**DOCUMENT 00 90 00
ADDENDUM**

ADDENDUM NO. [1] Date: February 17, 2020

**RE: WESTERN TECHNICAL COLLEGE
 APPRENTICESHIP CENTER REMODEL
 2860 21ST PLACE SOUTH
 LA CROSSE, WISCONSIN 54601
 HSR PROJECT NO. 19021**

This Addendum consists of [2] page, [1] specification sections and [9] 30 x 42 drawings.

1 PLUMBING UNDERFLOOR DEMOLITION PLAN
 1/8" = 1'-0"

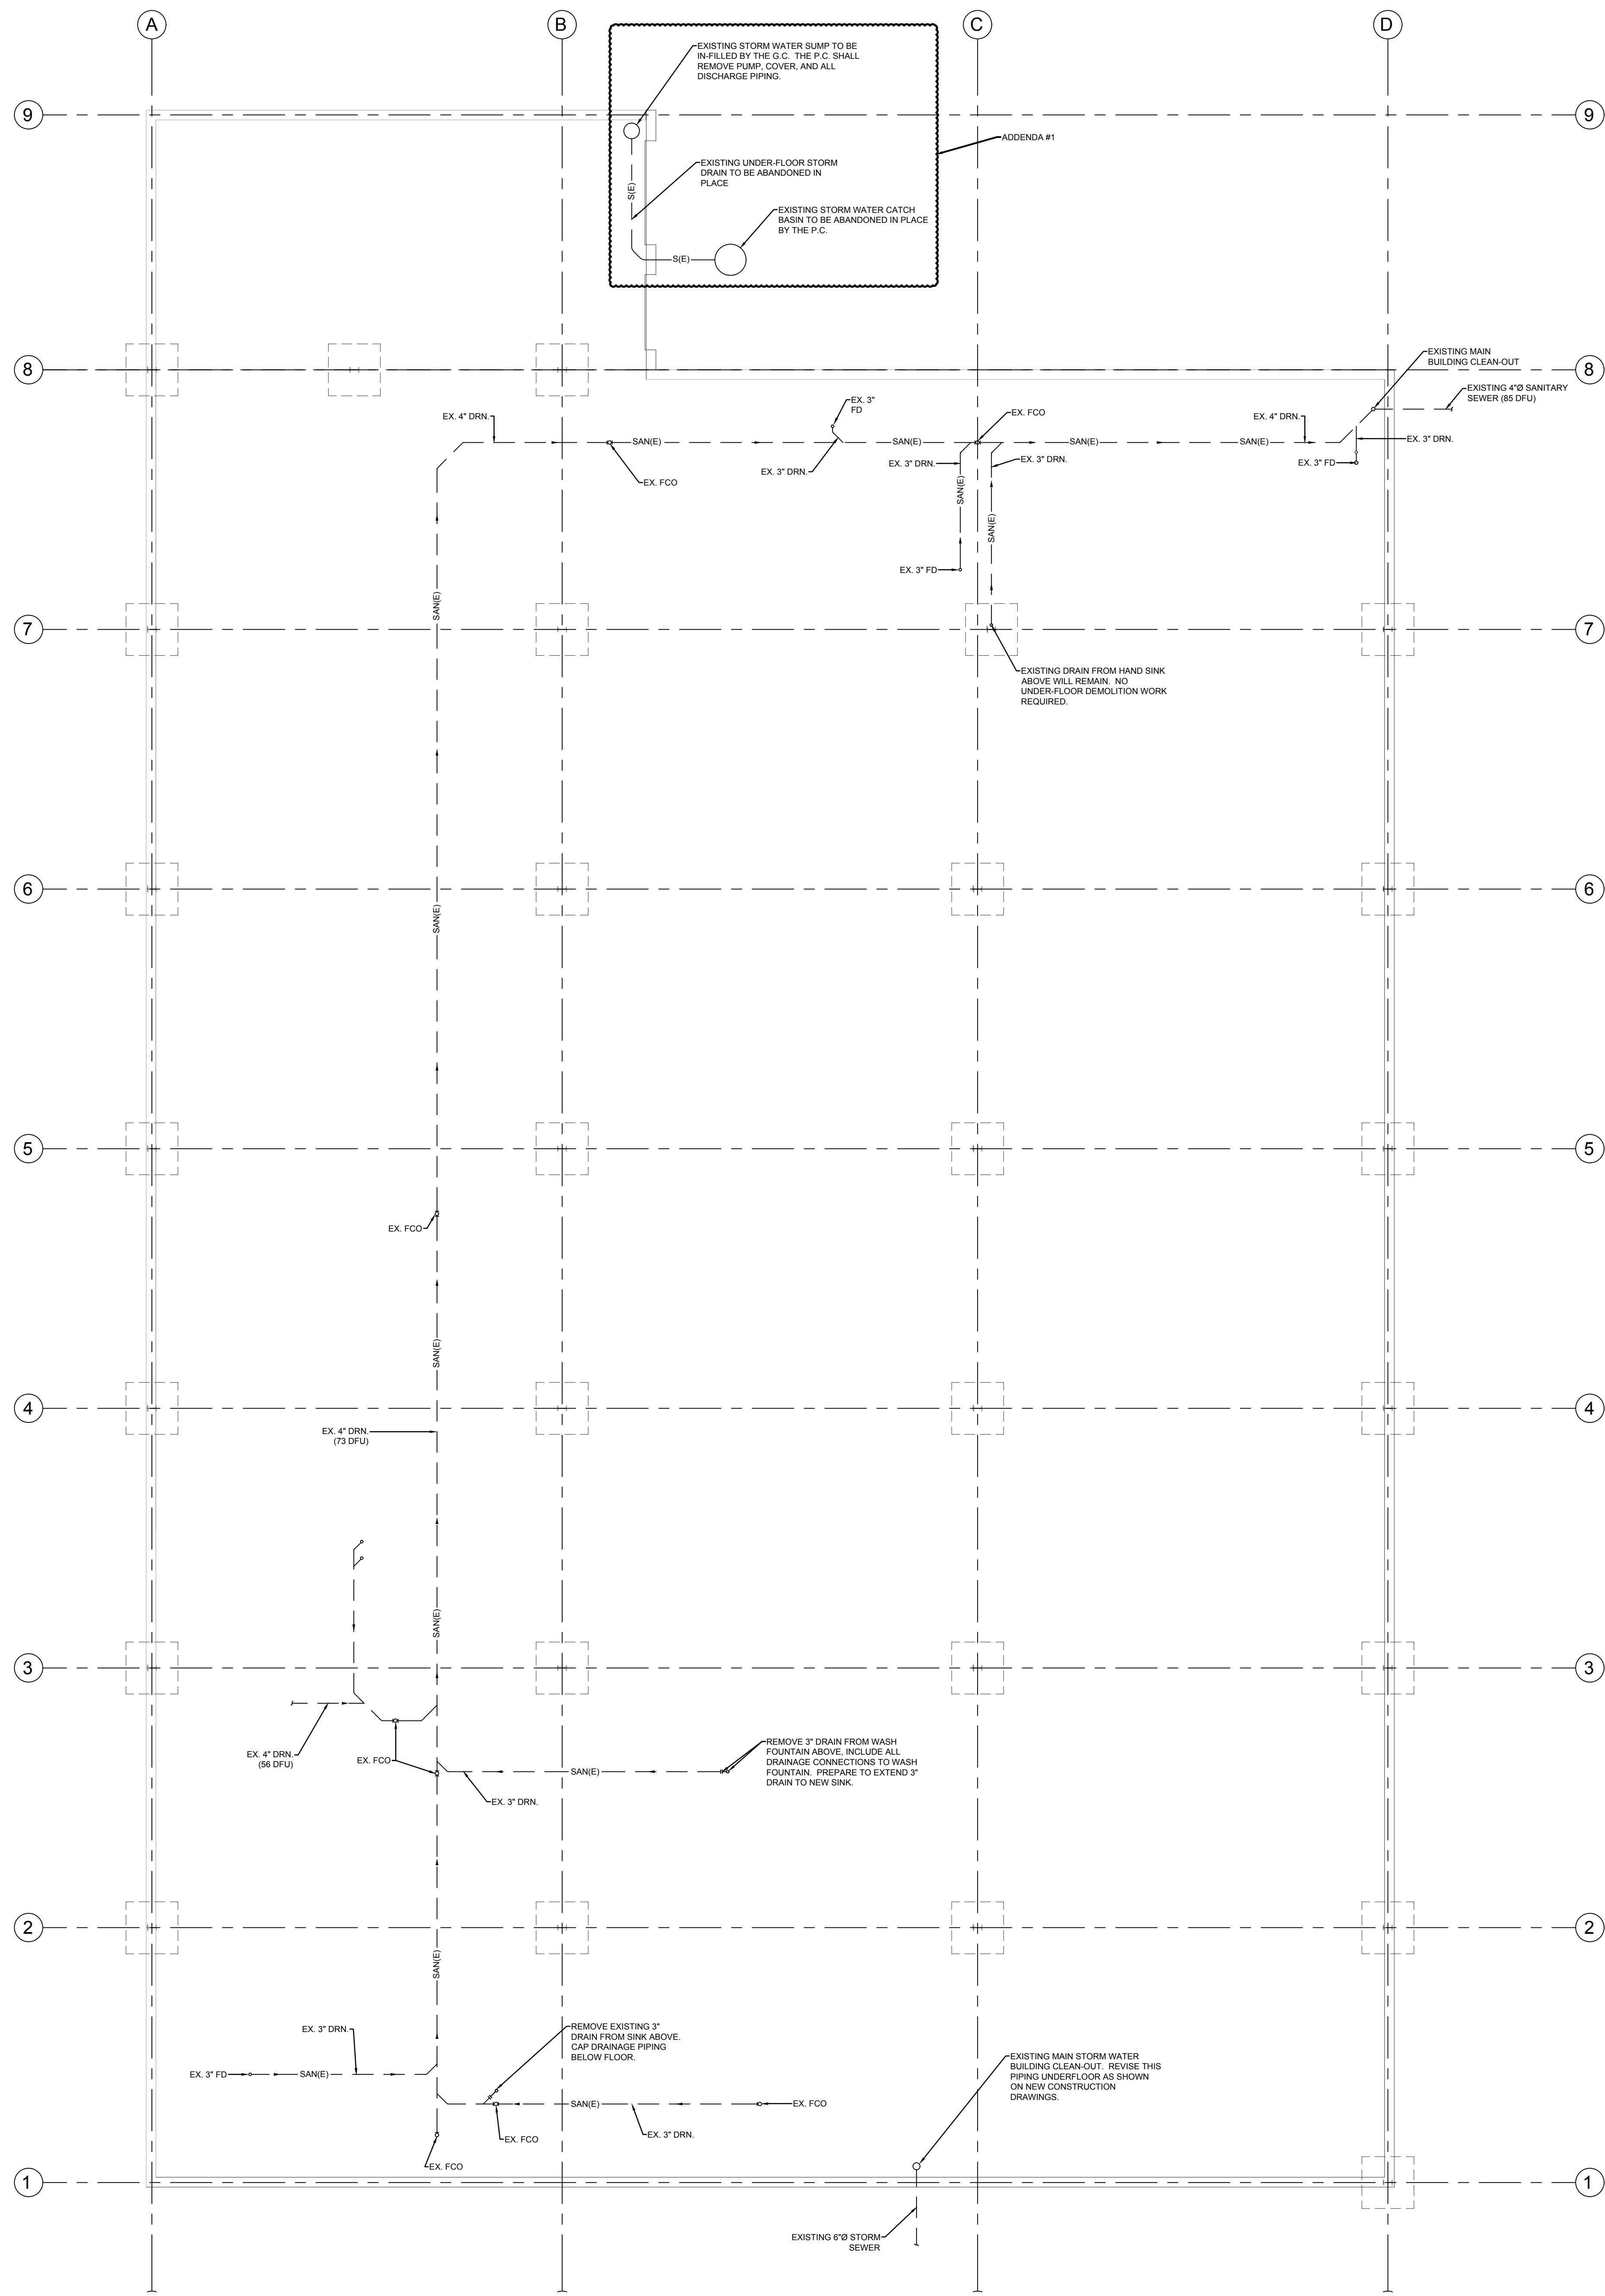
6. Sheet A120 ROOF 30 x 42 attached hereto
 - a. Revisions clouded on Drawing.
7. Sheet P090 PLUMBING UNDERFLOOR DEMOLITION PLAN 30 x 42 attached hereto.

- a. Revisions clouded on Drawing.
8. Sheet P091 PLUMBING FIRS FLOOR DEMOLITION PLAN 30 x 42 attached hereto.
 - a. Revisions clouded on Drawing.
9. Sheet P101 PLUMBING FIRST FLOOR PLAN – NEW WORK 30 x 42 attached hereto.

1 PLUMBING FIRST FLOOR PLAN - NEW WORK
1/8" = 1'-0"

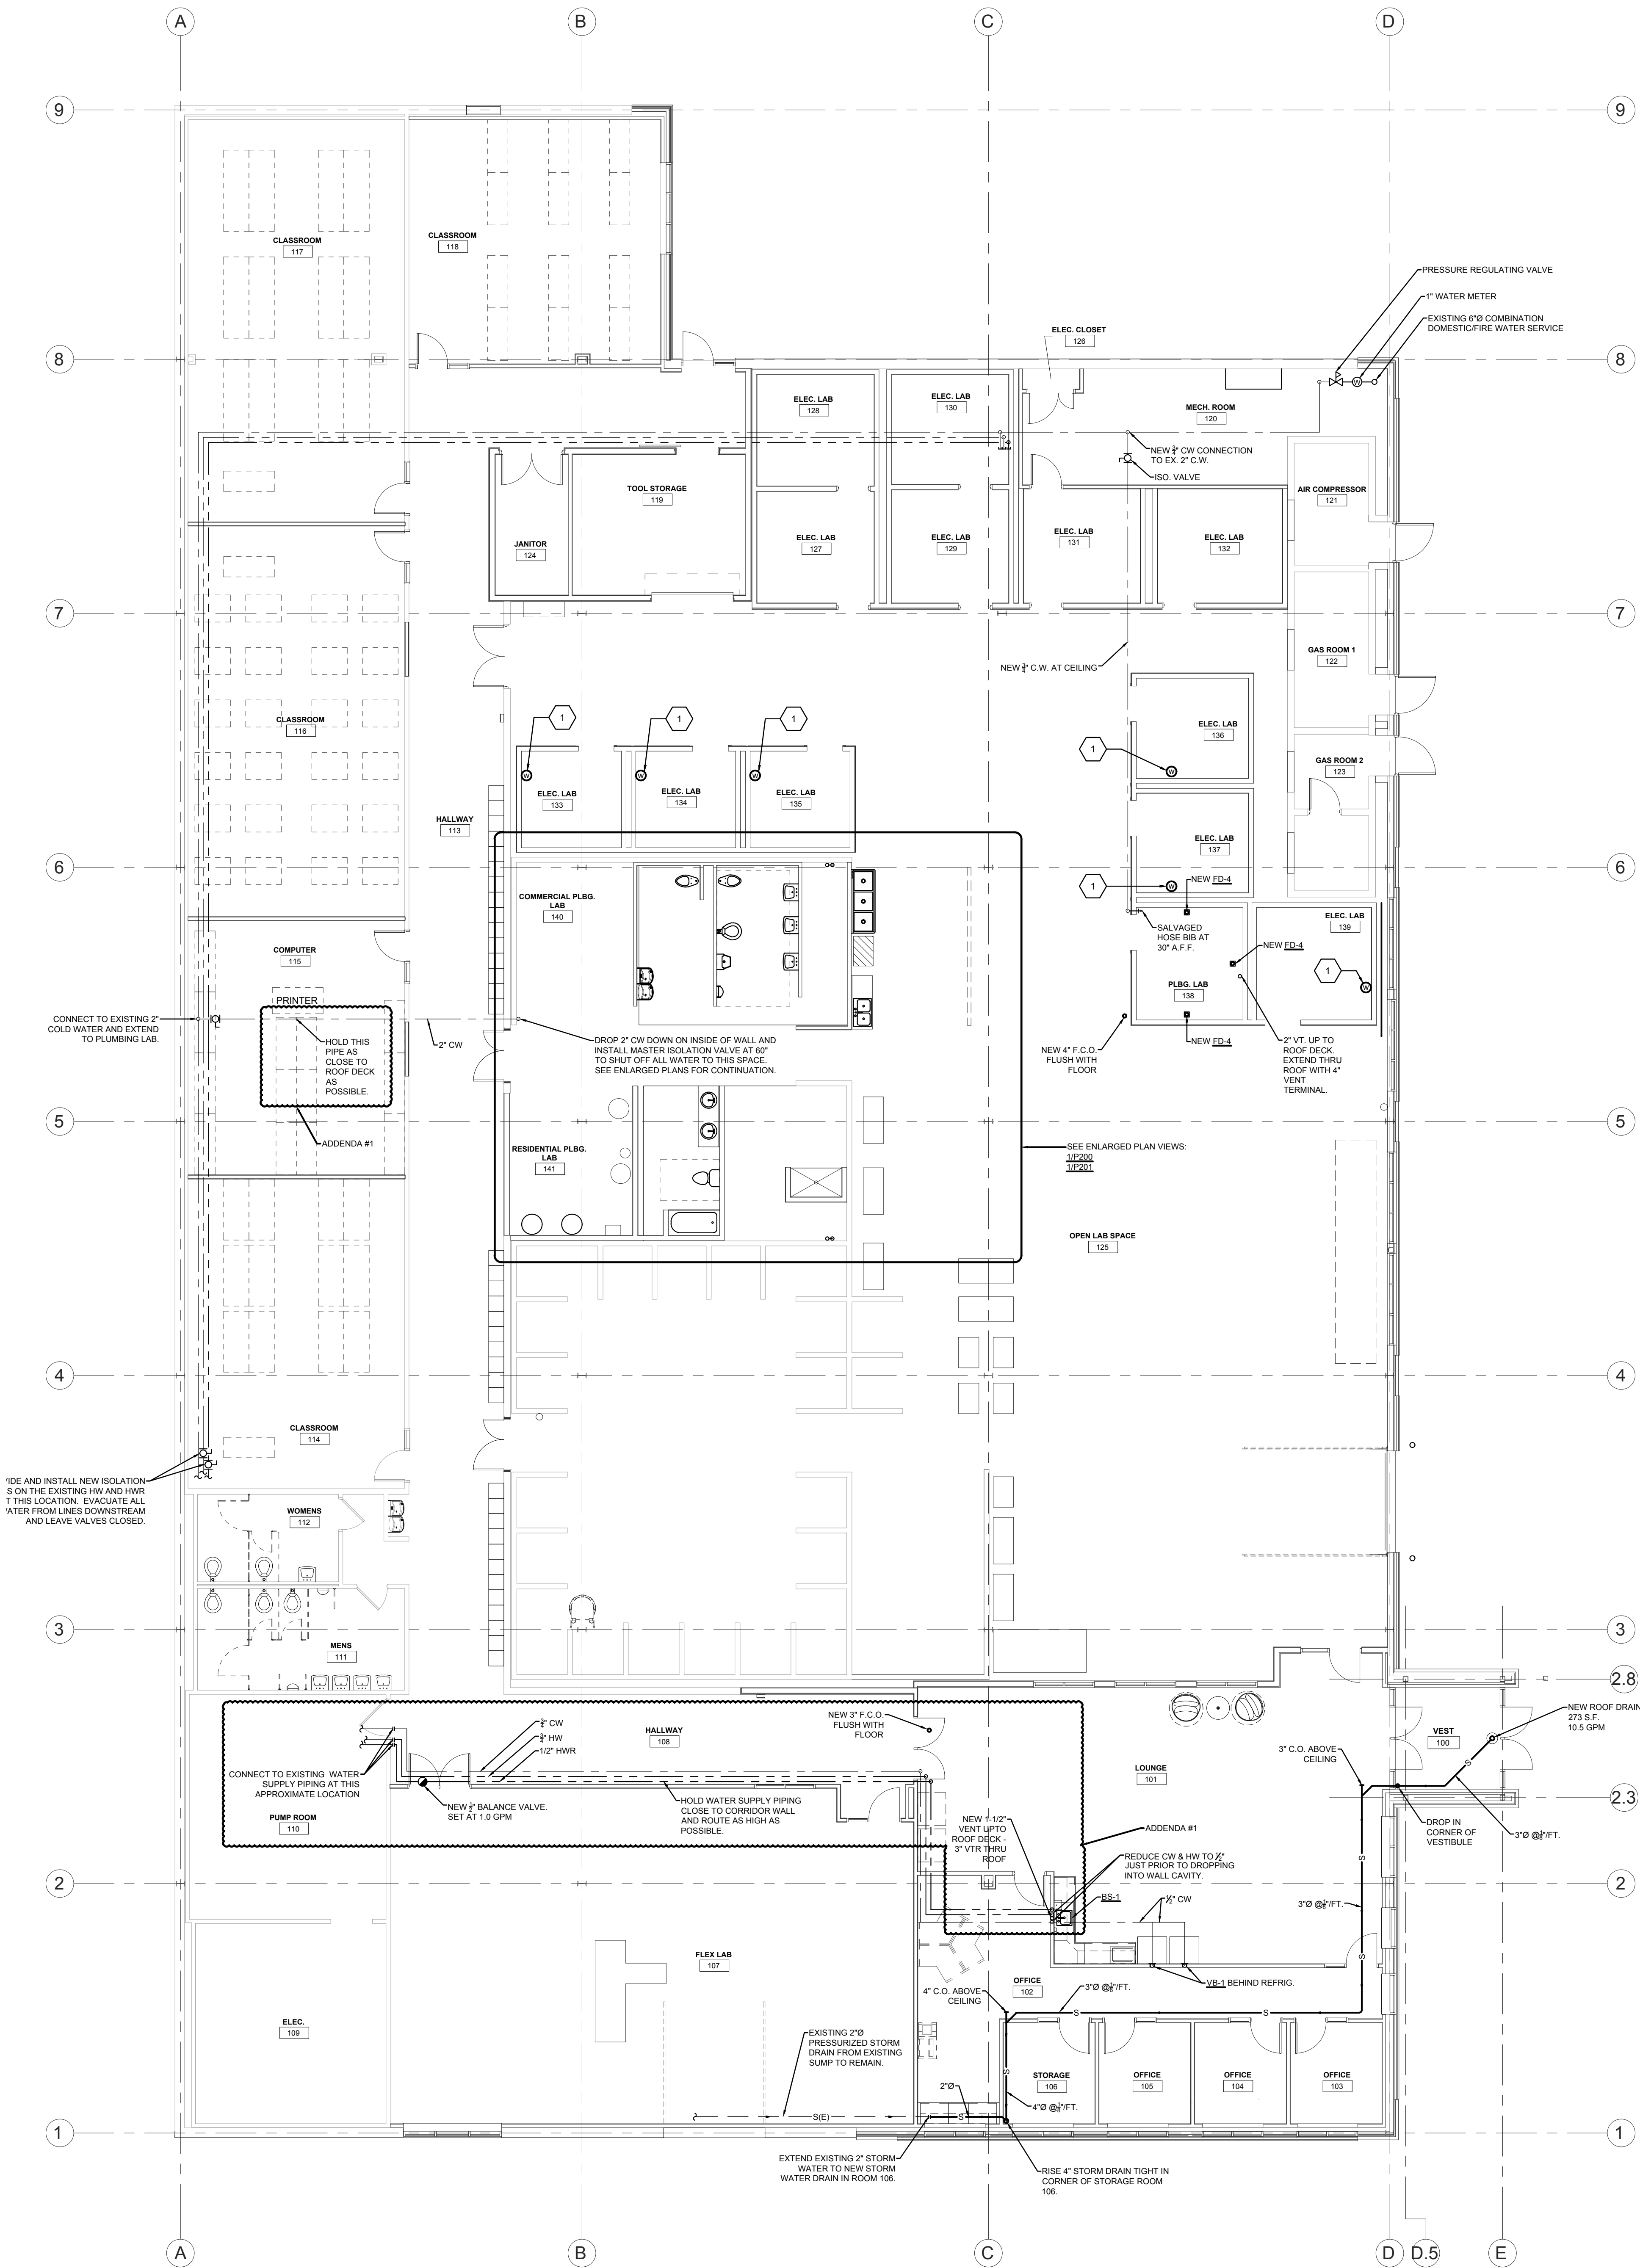
- a. Revisions clouded on Drawing.
10. Sheet P200 PLUMBING ENLARGED UNDERFLOOR PLAN 30 x 42 attached hereto.
 - a. Revisions clouded on Drawing.
11. Sheet P201 PLUMBING ENLARGED FIRST FLOOR PLAN 30 x 42 attached hereto.
